Submission with regard to Development Application DA2023/1289 Demolition works and construction of Shop Top Housing 1112-116 Barrenjoey Road, Palm Beach, NSW

I write regarding the above Development Application DA2023/1289 (subject DA) to make a submission on behalf of the Palm Beach and Whale Beach Association (my clients).

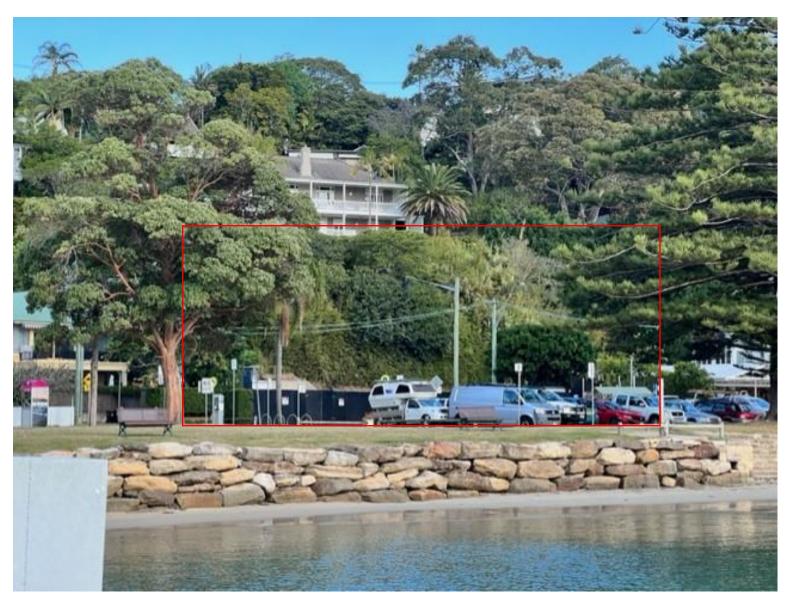
Additional view perspective should include the view of the site from Palm Beach wharf, from Pittwater Park and from a north-south perspective along the Barrenjoey Road (all key entry points to the area).

- **Comment:** The proposed development would significantly diminish important view corridors when arriving at Palm Beach from the Palm Beach Wharf, from Pittwater Park, from the Pittwater Waterway and from either direction along the Barrenjoey Road.

Figure 3 - 8.5 m height plane breach – note the scale of adjacent development along the Barrenjoey Road and the direct correlation with where the height breach starts to occur.

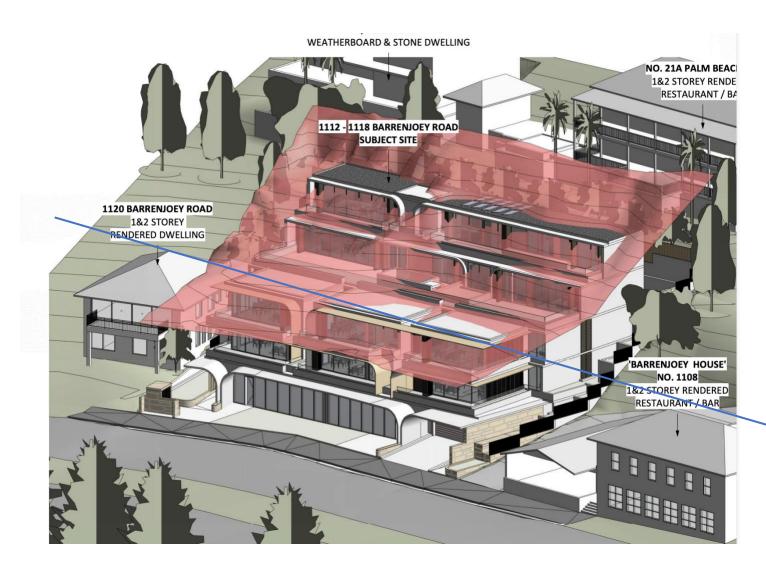
- Bulk excavation to a depth of 14.70m does not result in development that is *integrated* with landform and landscape.
- The removal of the escarpment landscaping to the rear of the site does not enable a development to be integrated into the landscape.
- The building height will exceed the height of the tree canopy see drawing no. A0201.
- The bulk and scale of the development is at odds with the horizontal massing of the existing built form and would appear as an incongruous structure and entirely dwarf the neighbouring 1-2 storey dwelling houses and adjacent heritage listed Barrenjoey House (see figures 3 and 4 of this objection).

**Comment:** The proposed development fails to meet this objective, as already detailed in this objection and as shown in figures 3 and 4.

Clause 4.3 (2D) (a) - The height breach cannot be considered as minor. The submitted height plane diagrams demonstrate a breach of the maximum height limit at 3 of the 5 levels proposed (levels 2, 3 and 4). The top two levels have been recessed into the site and overhang the rear setback in an attempt to reduce the breach and give rise to additional impact on neighbouring amenity, visual impacts and building separation distances. A breach of the maximum height of buildings across 3 of 5 levels of a development cannot be considered as minor.

- Remove levels 3 and 4 from the proposed development and strictly comply with the 8.5 metre height limit.
  - Pull back the rear and side elevations of the proposed development to strictly comply with the ADG. 6-12 metre building separation distances are required.
